Attachment A
Section 92 Response,
parts 1, 2, 3

25 January 2024

Attachment A: Section 92 response

Table 1: Proposed Flood Hazard Condition – changes since lodgement and rationale

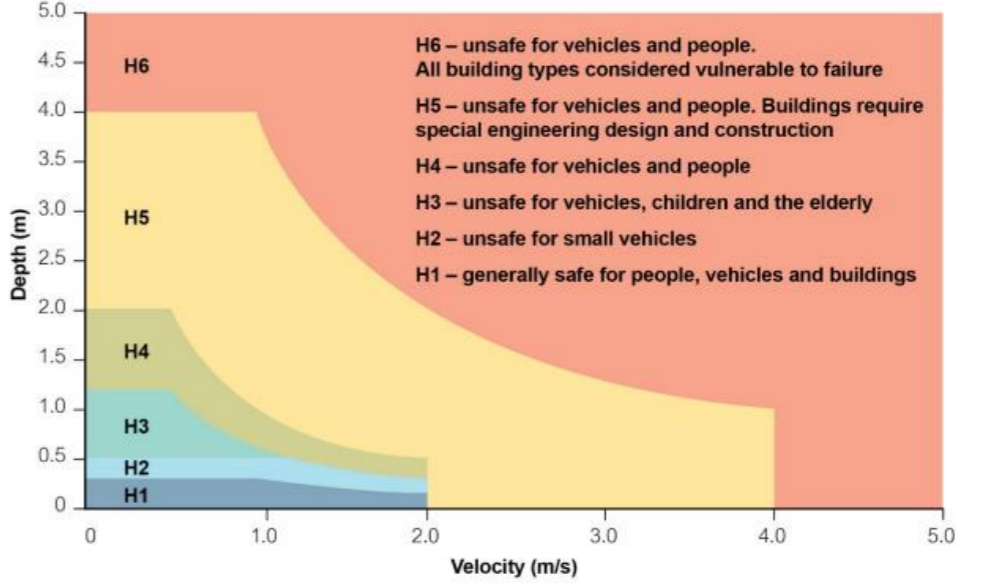
Condition as lodged Sept 2023 (Appendix B, condition 10)	Proposed change to condition	Rationale for change from conditions as lodged
(a) The Project shall be designed to achieve the following flood risk outcomes:	The Project shall be designed to achieve the following flood risk outcomes:	N/A
<ul style="list-style-type: none"> i. no increase in flood levels in a 1% AEP event for existing authorised habitable floors that are already subject to flooding or have a freeboard less than 150mm; 	<ul style="list-style-type: none"> no increase in flood levels in a 1% AEP event for existing authorised habitable floors that are already subject to flooding or have a freeboard less than 150mm500mm; 	<p>A site assessment was carried out to estimate the amount of freeboard at buildings that might be affected by flooding close to the proposed NoR boundary (refer Section 4 and the maps in Appendix 1 of the Supplementary Flood Hazard Assessment). When the freeboard was estimated, the majority of those existing floors assessed were either flooded or within 150mm of flooding. Changing to 500mm had a minor increase in the number of floors subject to this condition but the controlling criteria was typically the building with freeboard less than 150mm.</p> <p>The new criteria also provides better protection for relatively new buildings that may be constructed prior to lodgement of the OPW– which is relevant to NoRs near flooding within the Future Urban Zone.</p> <p>Increasing freeboard to 500mm for these types of buildings aligns with freeboard standards in the AC Stormwater Code of Practice for new builds.</p> <p>It is not intended to protect all future buildings – those constructed after the OPW are lodged are expected to set appropriate freeboard above the Post project flood level.</p>

<ul style="list-style-type: none"> ii. no more than a 10% reduction in freeboard in a 1% AEP event for existing authorised habitable floors with a freeboard over 150mm; 	<ul style="list-style-type: none"> no more than a 10% reduction in freeboard in a 1% AEP event for existing authorised habitable floors to maintain a minimum with a freeboard of over 150mm; 	<p>A percentage freeboard reduction is not needed if a freeboard of 500mm is utilised in criteria i.</p>

Condition as lodged Sept 2023 (Appendix B, condition 10)	Proposed change to condition	Rationale for change from conditions as lodged
<p>iii. no increase in 1% AEP flood levels for existing authorised community, commercial and industrial building floors that are already subject to flooding;</p>	<p>no increase in 1% AEP flood levels for existing authorised community, commercial, industrial and network utility building floors that are already subject to flooding or have a freeboard of less than 300mm;</p>	<p>This criterion has been introduced to address flood effects as these types of building are present in the Project area – such as east of SH1 (NoR4).</p> <p>Increasing the freeboard to 300mm for these types of buildings aligns with freeboard standards in the AC Stormwater Code of Practice for new builds.</p> <p>Given the potential town centre areas in the Future Urban Zone there is potential for more of them to be constructed prior to the lodgement of the OPW. The new criteria provides better protection for relatively new buildings.</p>

<p>vi. no new flood prone areas;</p>	<p>no new flood prone areas; and</p>	<p>No change.</p>
<p>vii. no more than a 10% average increase of flood hazard (defined as flow depth times velocity) for main access to authorised habitable dwellings existing at time the Outline Plan is submitted. The assessment shall be undertaken for the 1% AEP rainfall event.</p>	<p>No increase of flood hazard for main vehicle access to authorised habitable dwellings existing at time the Outline Plan is submitted. The assessment shall be undertaken for the 1% AEP rainfall event. Where Flood Hazard is:</p> <ul style="list-style-type: none"> • Velocity x depth >= 0.6 or • depth > 0.5m, or • velocity >2m/s. <p>no more than a 10% average increase of flood hazard (defined as flow depth times velocity) for main access to authorised habitable dwellings existing at time the Outline Plan is submitted. The assessment shall be undertaken for the 1% AEP rainfall event.</p>	<p>The wording has been changed to reflect the change from category H2 to H3 in the Australian Institute of Disaster Resilience 2017, Handbook 7, Managing the Floodplain. Using categories of protection, allows some changes to depth or velocity within category 2 while providing appropriate protection.</p> <p>The protection of both pedestrians and small vehicles are covered within category H2.</p>
